**AMHERST HEALTH DEPT.
TOWN OF AMHERST
HEALTH PERMITS**

TO: Amherst Board of Health
DATE: Oct. 8, 2007
RE: Review of Plans for the construction of a new Soil Absorption System at Lot H, Henry St., Amherst, MA

SUBSURFACE SEWAGE DISPOSAL PLAN
 AT HENRY STREET AMHERST, MASSACHUSETTS
 FOR THE CENTER FOR DESIGN ENGAGEMENT
 UMASS DEPARTMENT OF ART, ARCHITECTURE, AND ART HISTORY

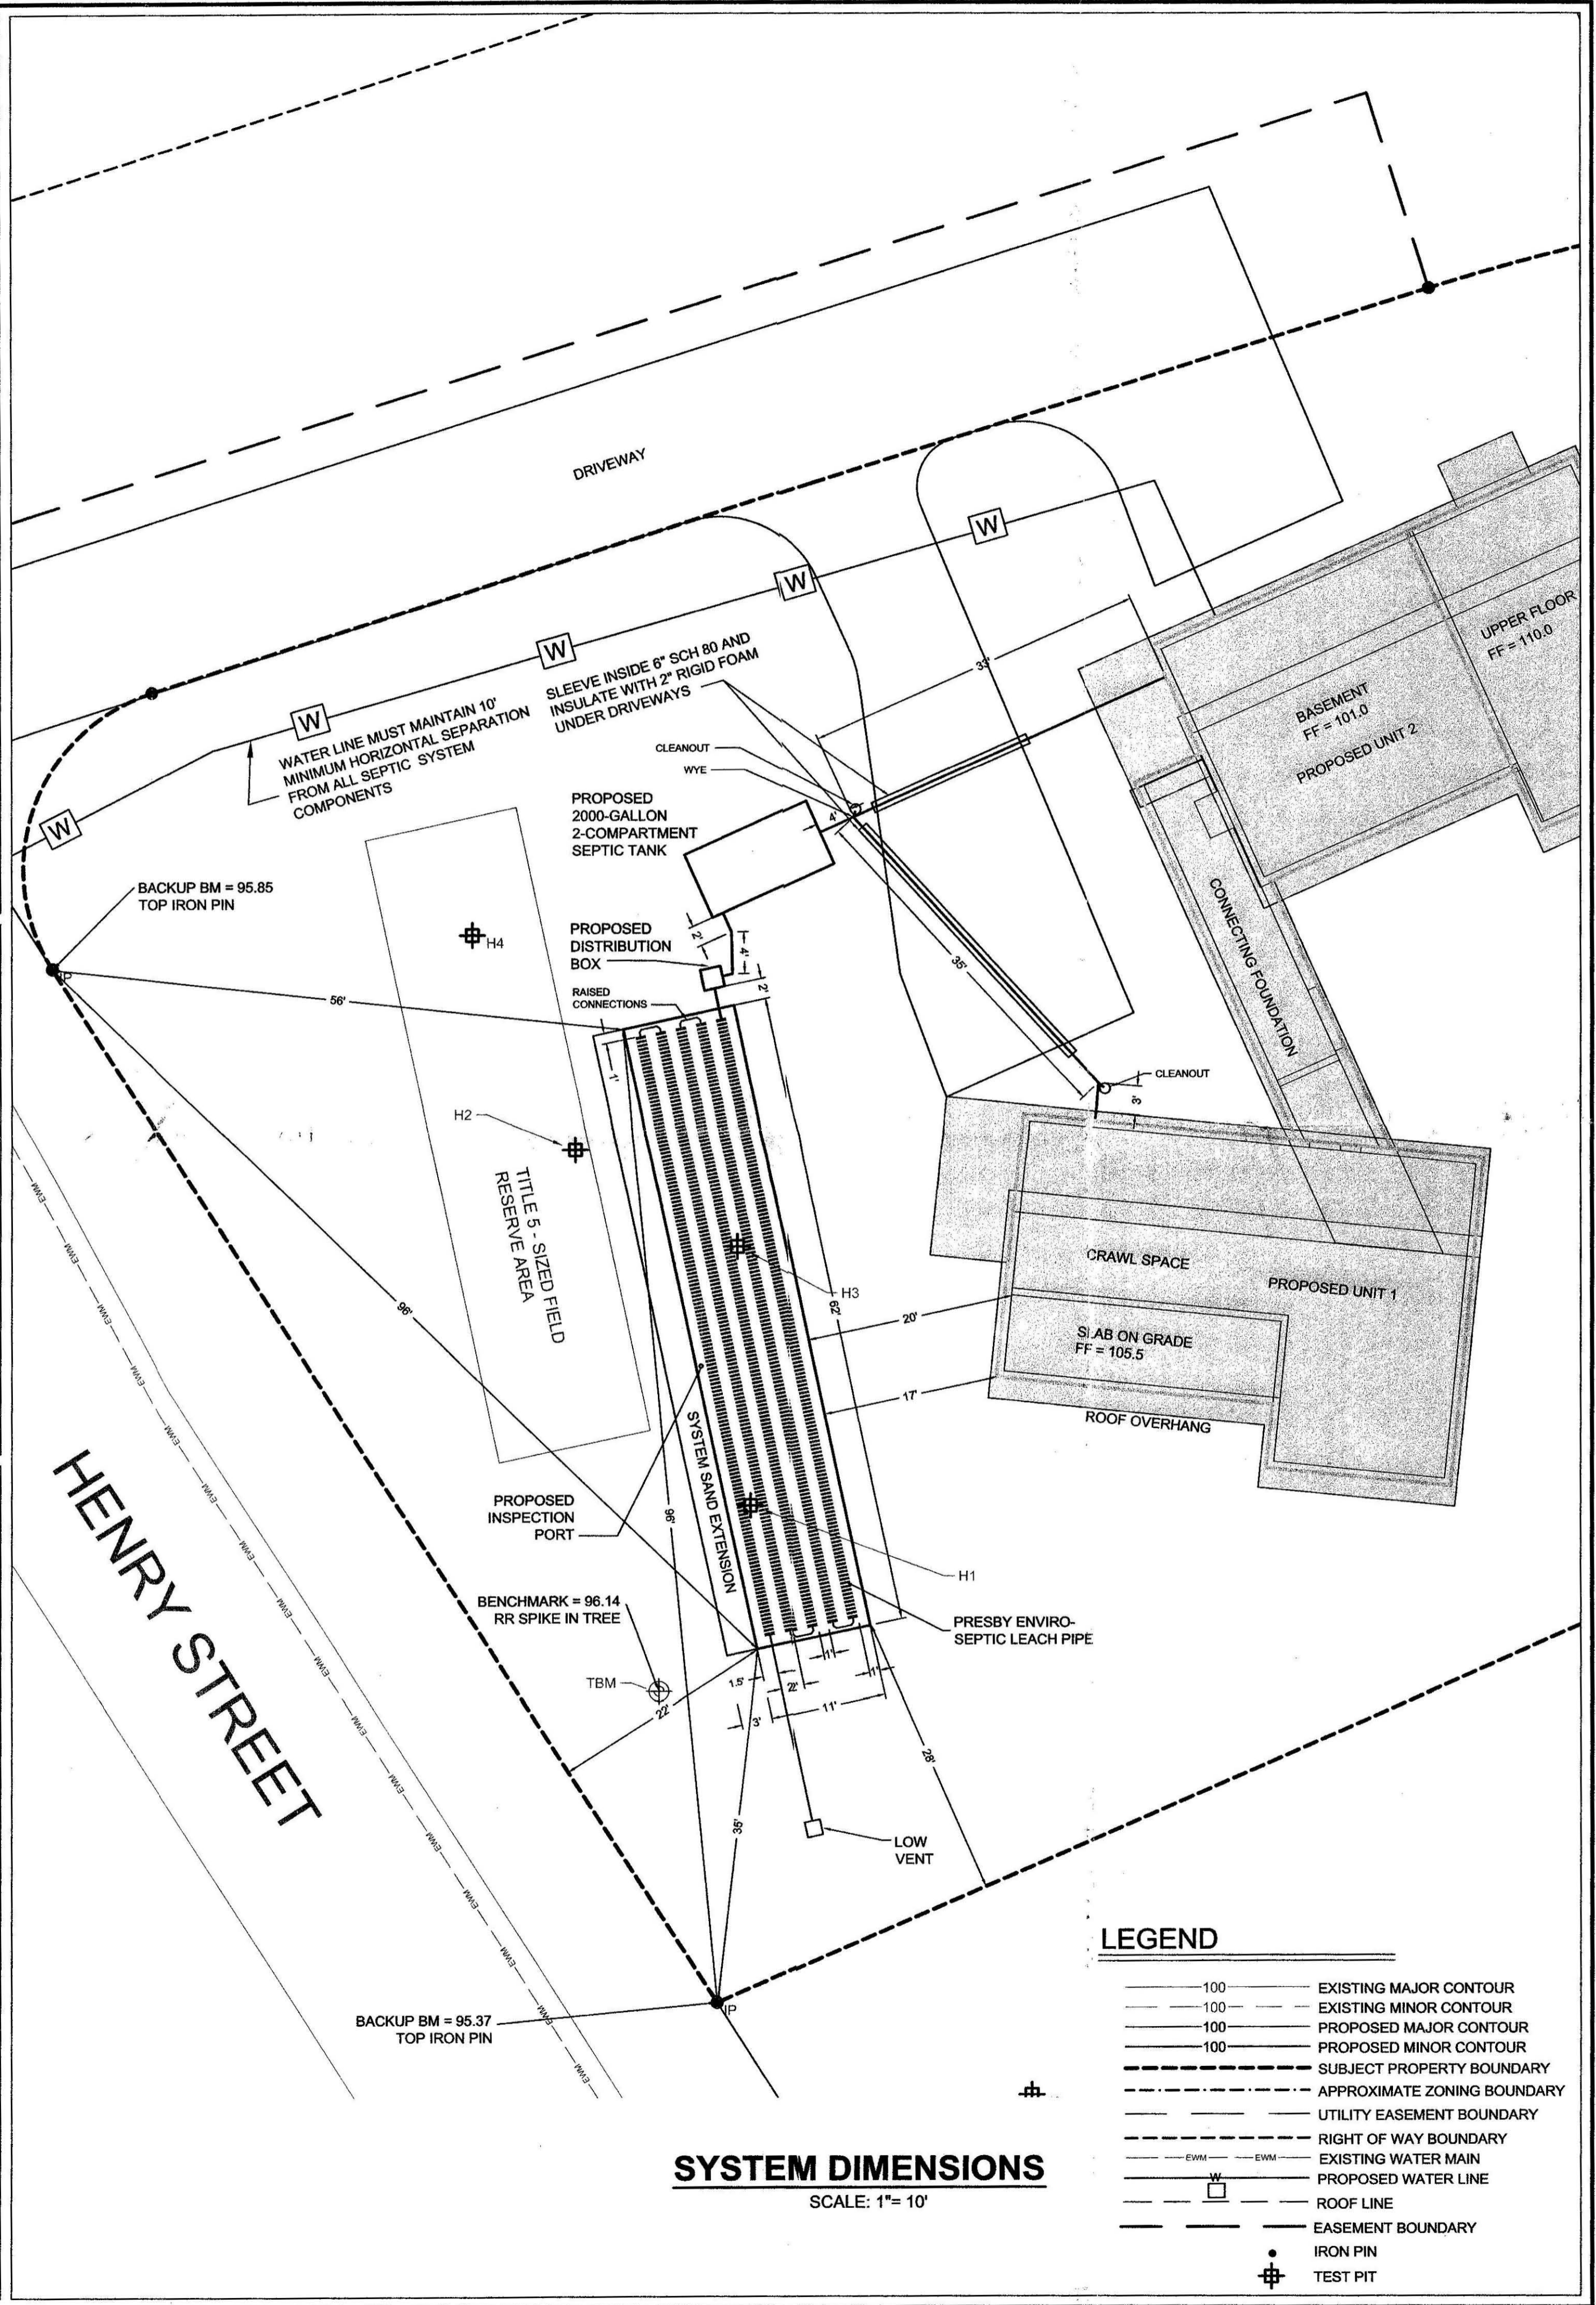
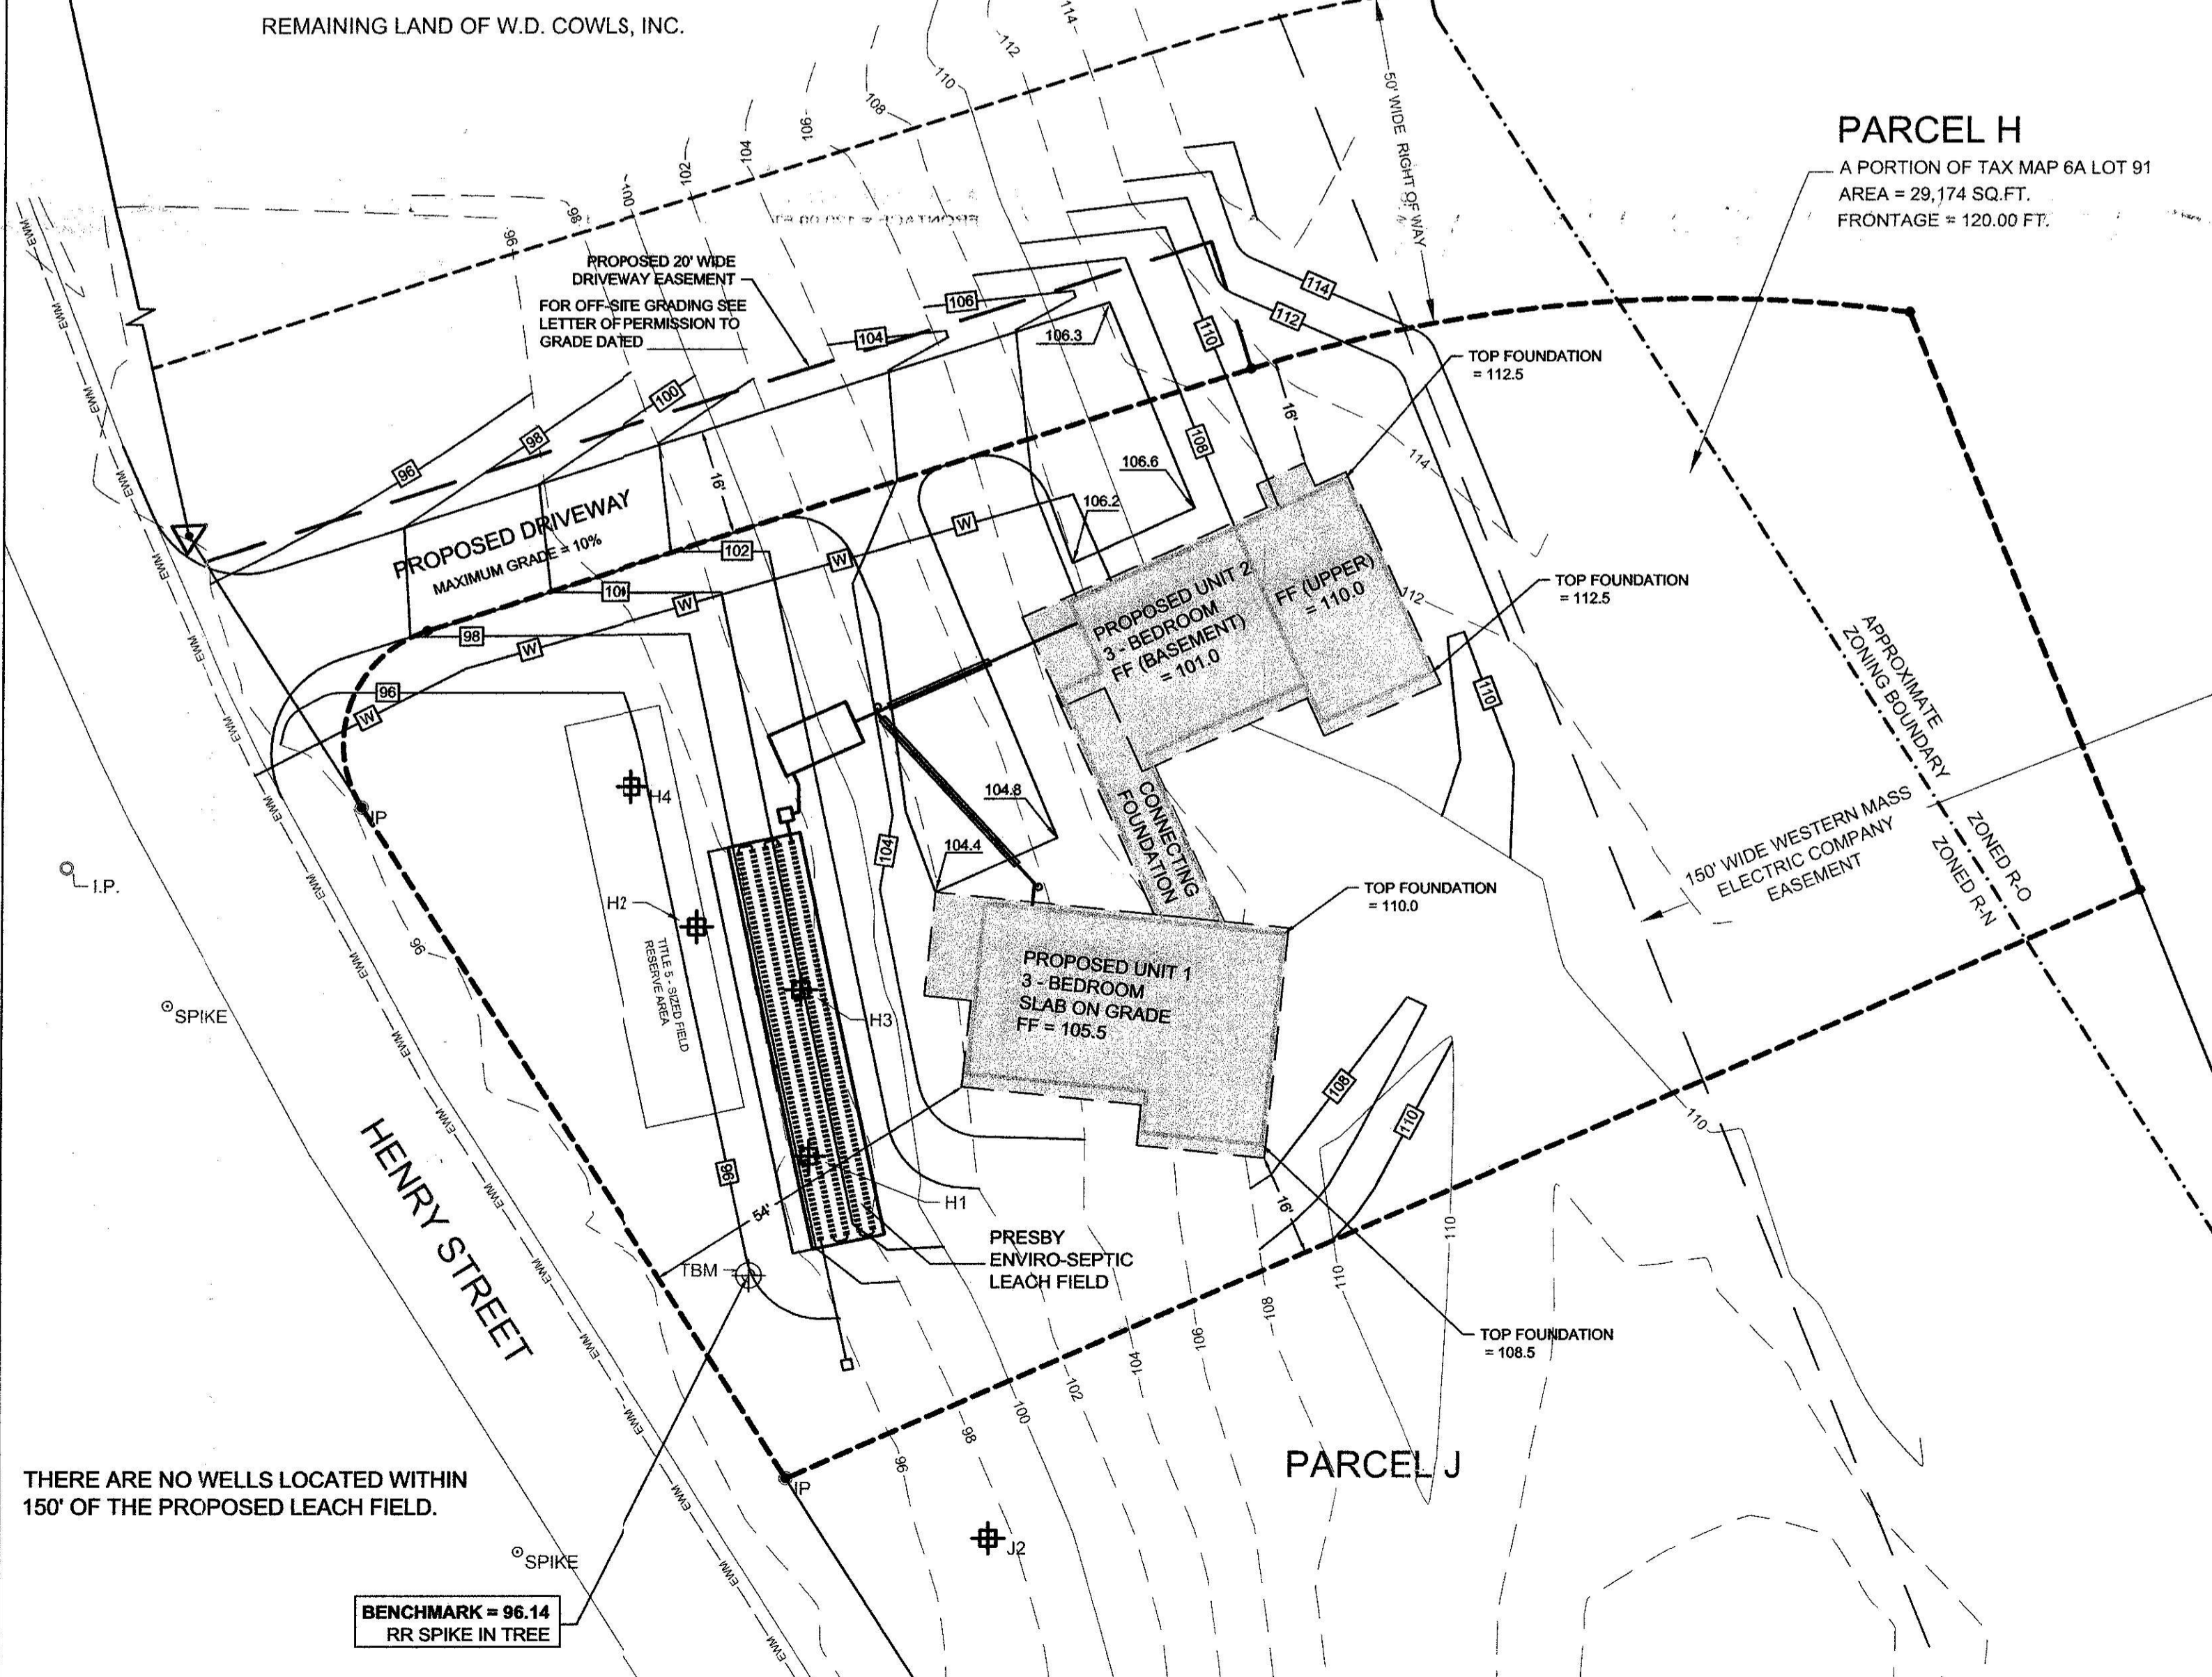
Conclusion: The design for the proposed SAS complies with all requirements of Title 5, 310 CMR 15.000 and the DEP Approval conditions for the Presby Alternative Technology system and I hereby approve the plans and issue the Disposal System Construction Permit with the following conditions:

- 1) This system must be installed by a contractor certified, by Presby Enviro-Septic, as being trained in the Presby installation techniques.
- 2) Utilization of the Presby system also requires that a notice of the use of Alternative Technology type SAS be recorded on the property deed.
- 3)
